Groundwater Application Review Summary Form

Application # G- 19367

GW Reviewer Phillip I. Marcy Date Review Completed: 12/20/2023

PUBLIC INTEREST REVIEW FOR GROUNDWATER APPLICATIONS

Well Statistics

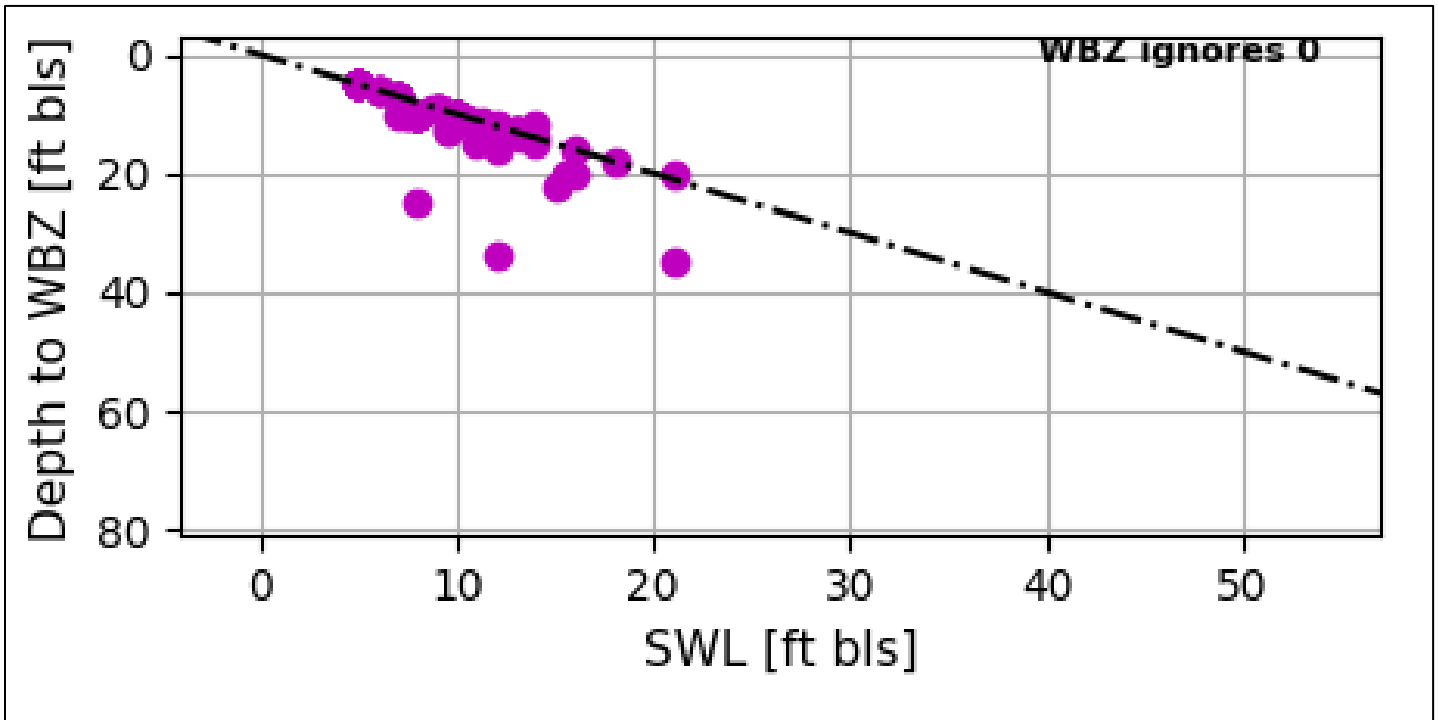
Local well logs typically report static water levels similar to the depth where groundwater was first encountered, suggesting unconfined conditions.
